Service Technical Information

MODEL NO. CSD-MD5/MD30/MD50/MD70
SUBJECT MD unit does not operate (mechanism lockup)

REF.No. :G - A0 - 050 - E0

DATE :07. JUL. 2000

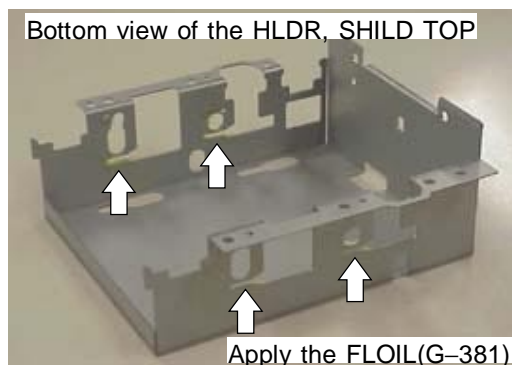
Verify that the pins of MD mechanism (7ZG-9) indicated with arrows in the figure fit into the slits properly.

If the pins are off the slits, return the pins to the slits and then replace HLDR, SHILD TOP.

When replacing HLDR, SHILD TOP, be sure to apply FLOIL (G-381) from inside.
